| REV | DATE     | DESCRIPTION        | DN | AP |
|-----|----------|--------------------|----|----|
| 8   | 12/11/25 | DA Response        | NC | MF |

SHEET TITLE  
BASEMENT 1 PLAN

PROJECT  
ORAN PARK  
COMMERCIAL 5  
PROJECT  
NO 12

GADIGAL COUNTRY  
79 MYRTLE STREET  
CHIPPENDALE NSW, 2008 AUSTRALIA  
+61 2 9311 8222 ARCHITECTSAJC.COM  
ABN 53 003 782 250

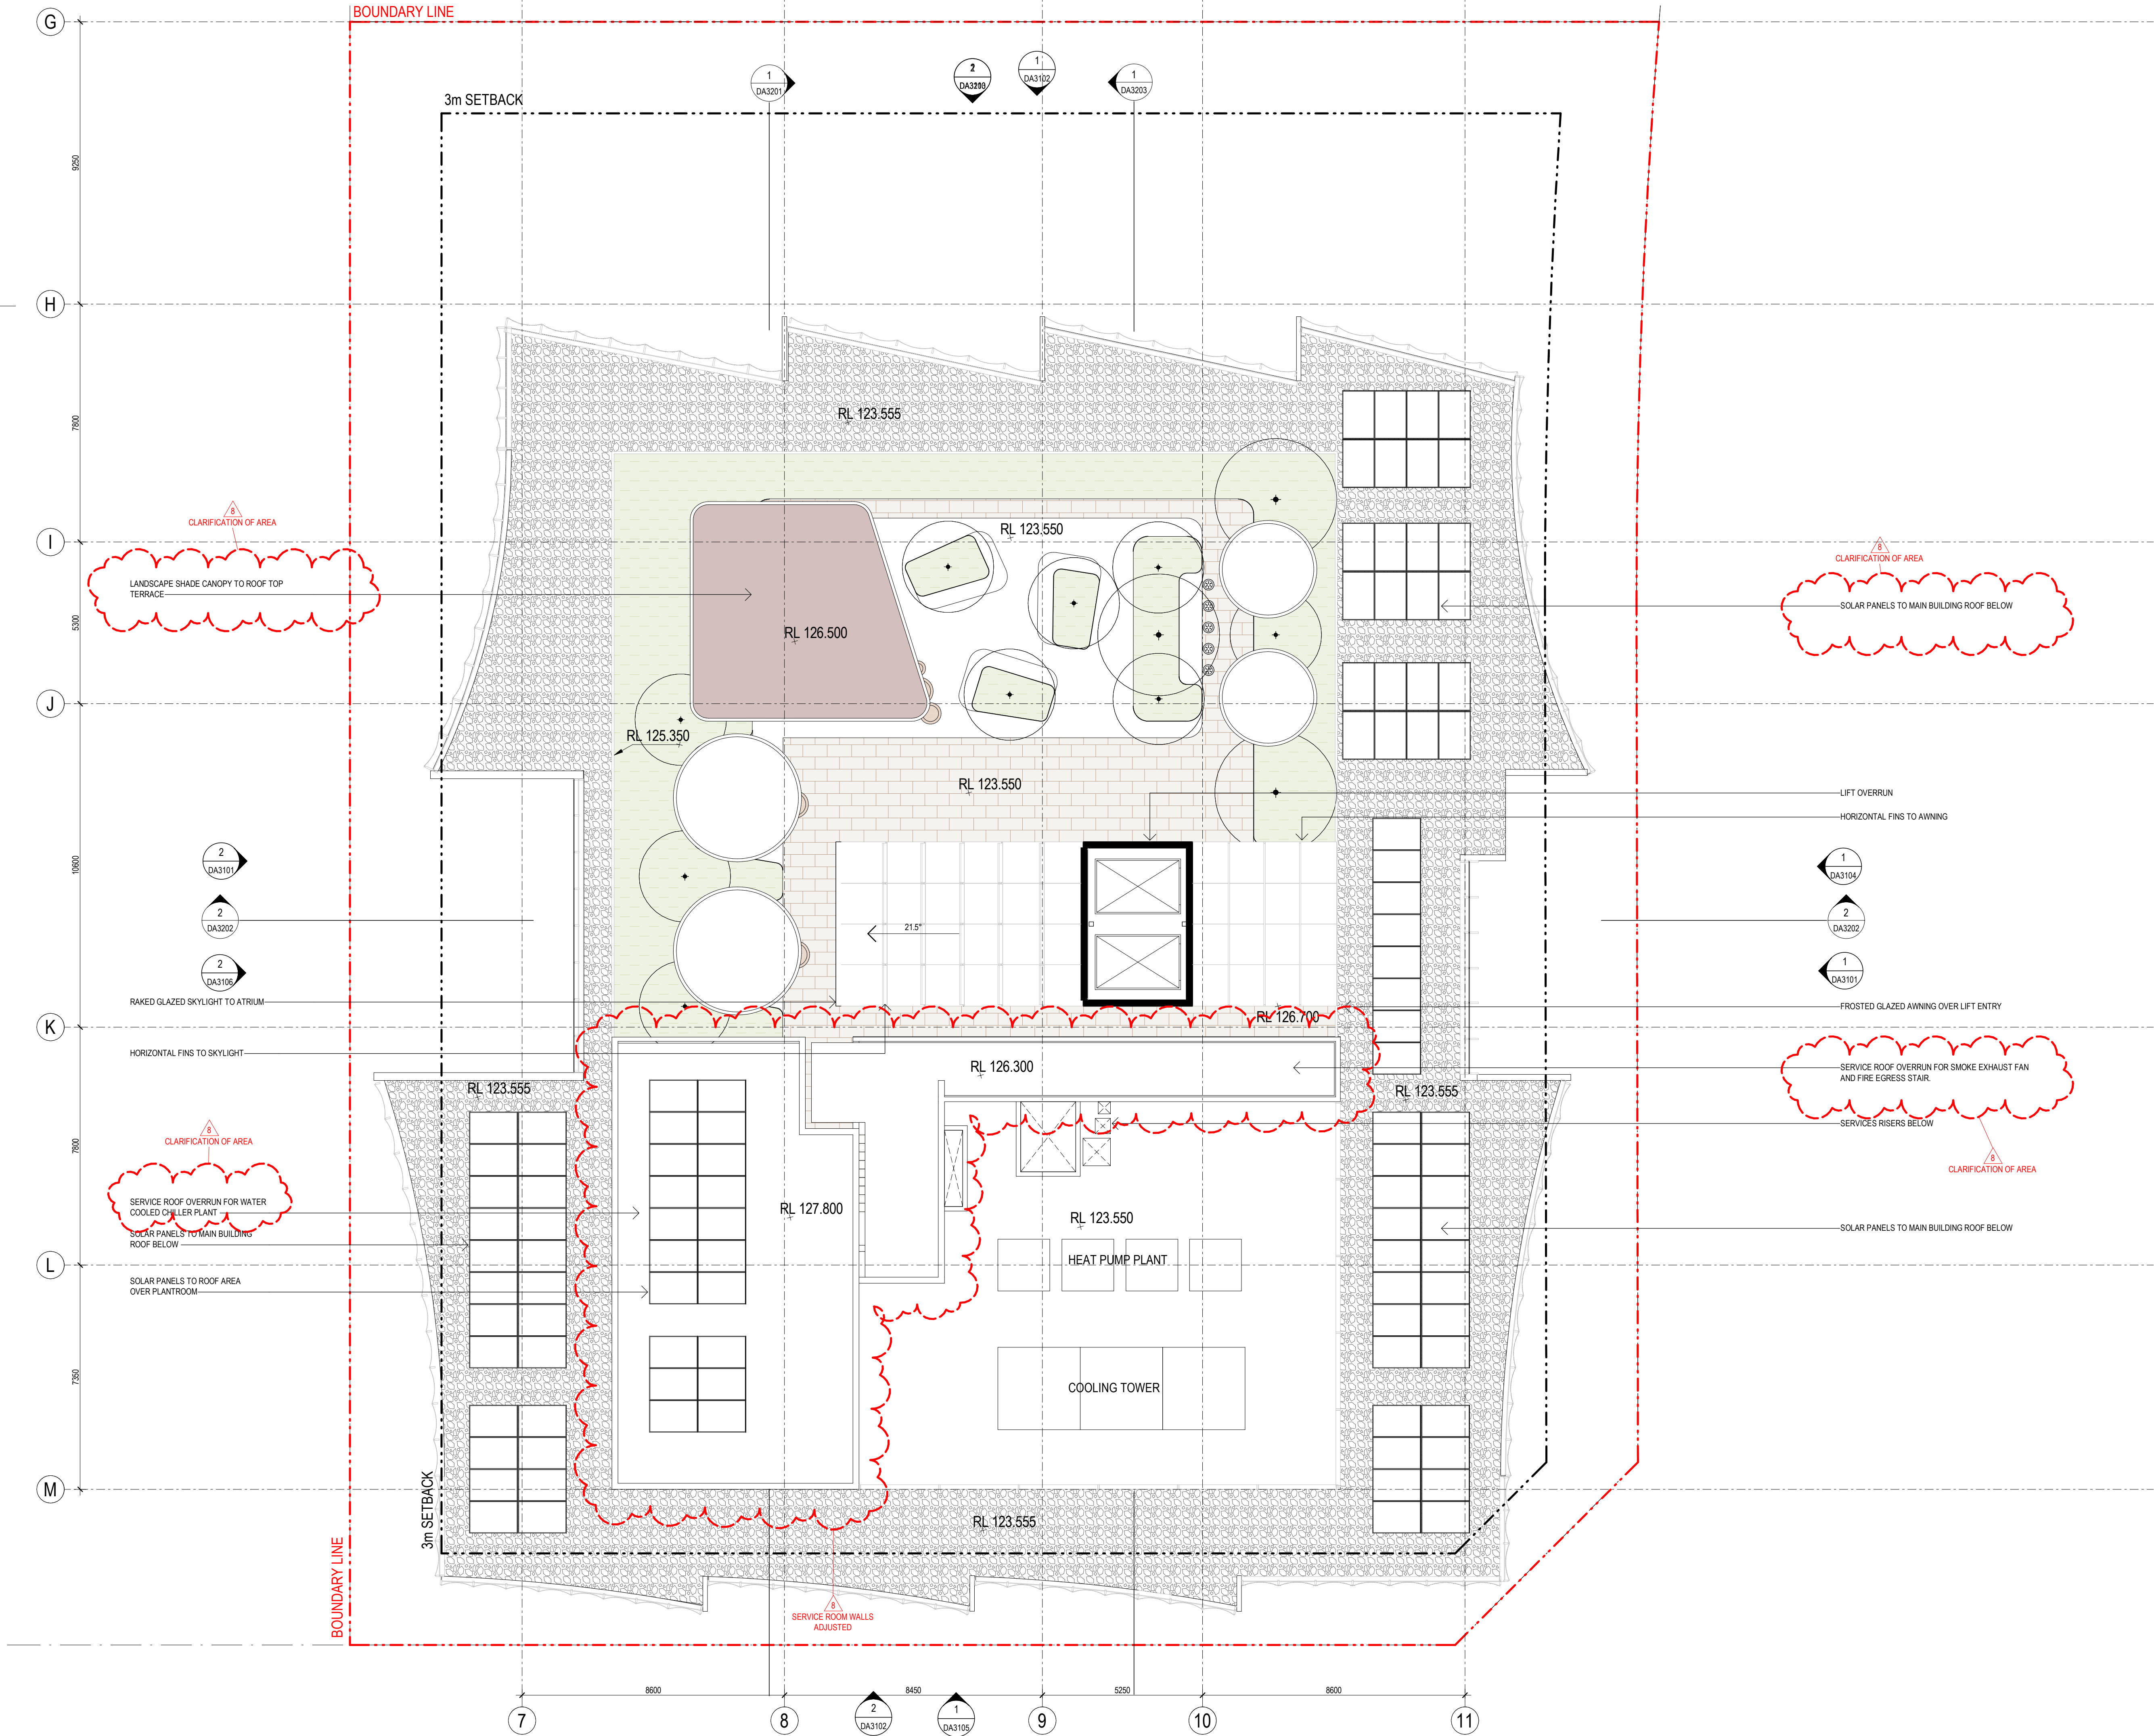
GENERAL NOTE:  
DIMENSIONS ADDED TO CAR PARK AREAS  
THROUGHOUT BASEMENT LEVELS

7  
ADDITIONAL DIMENSIONS  
ADDED

ADDITIONAL DIMENSIONS ADDED

GENERAL NOTE:  
DIMENSIONS ADDED TO CAR PARK AREAS  
THROUGHOUT BASEMENT LEVELS

NEW SHEET ADDED TO SHOW  
DETAILED CARPARKING SPACES  
UNDERNEATH RESI 4.

1  
CAR SPACE NUMBERS  
UPDATED AND ADDITIONAL  
VISITOR SPOT ADDED AND  
EV SPACES ADDED

7 WINTER SOLSTICE - 3PM  
1:1000

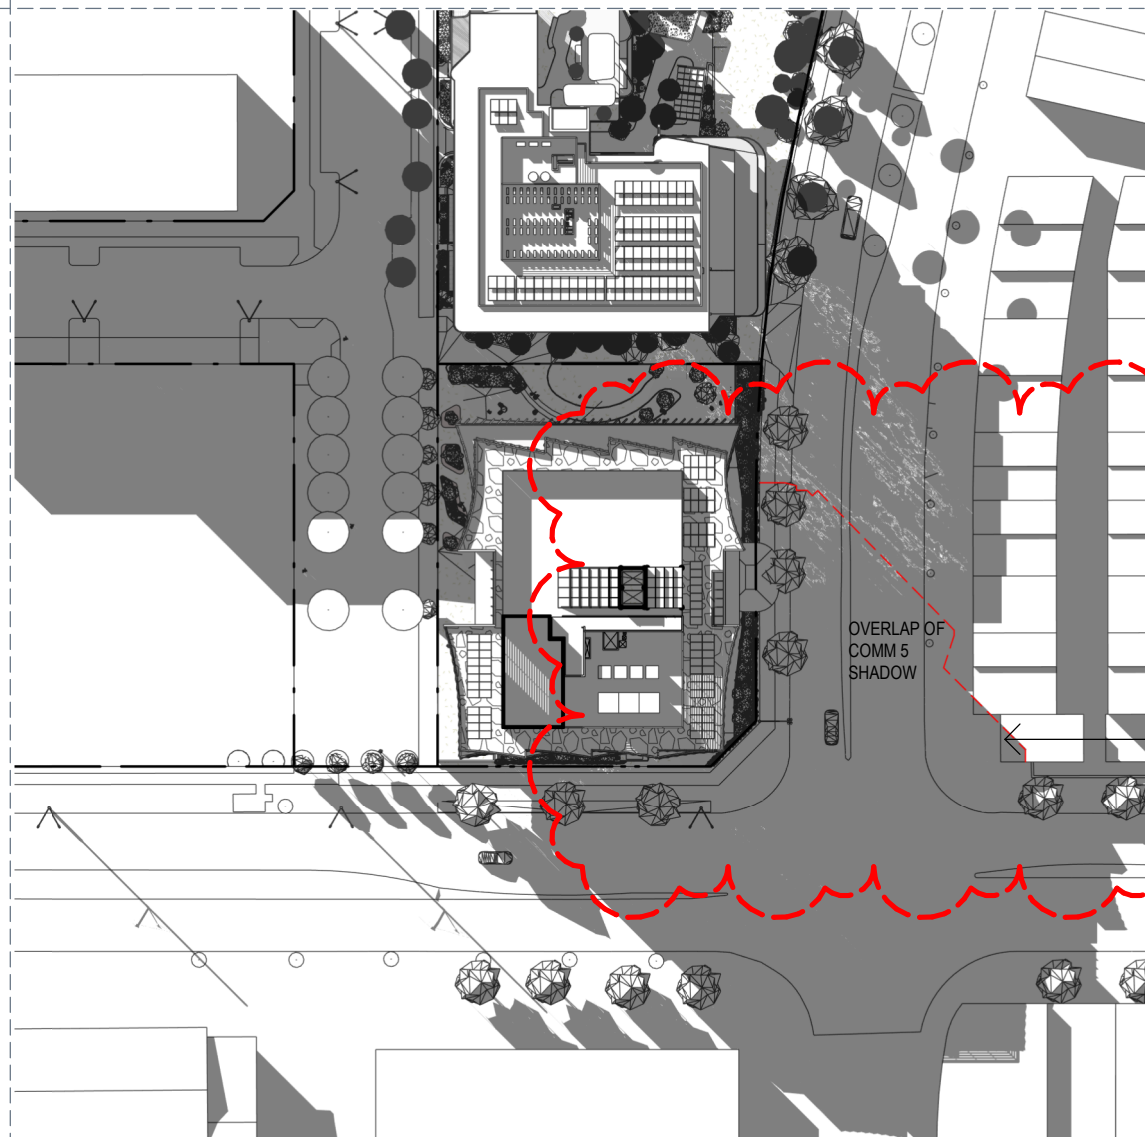
LINE INDICATING EXTENT  
OF COMMS 5 SHADOW AT  
3PM ONTO NEIGHBOURING  
PROPERTIES

OVERLAP OF  
COMMS 5  
SHADOW

SHADOW OVERLAPS ON TO SMALL PORTION  
OF HOUSE'S FRONTAGES/ROOF  
- NO SHADOW IMPACT INTO LIVING SPACES  
AT REAR OF PROPERTY
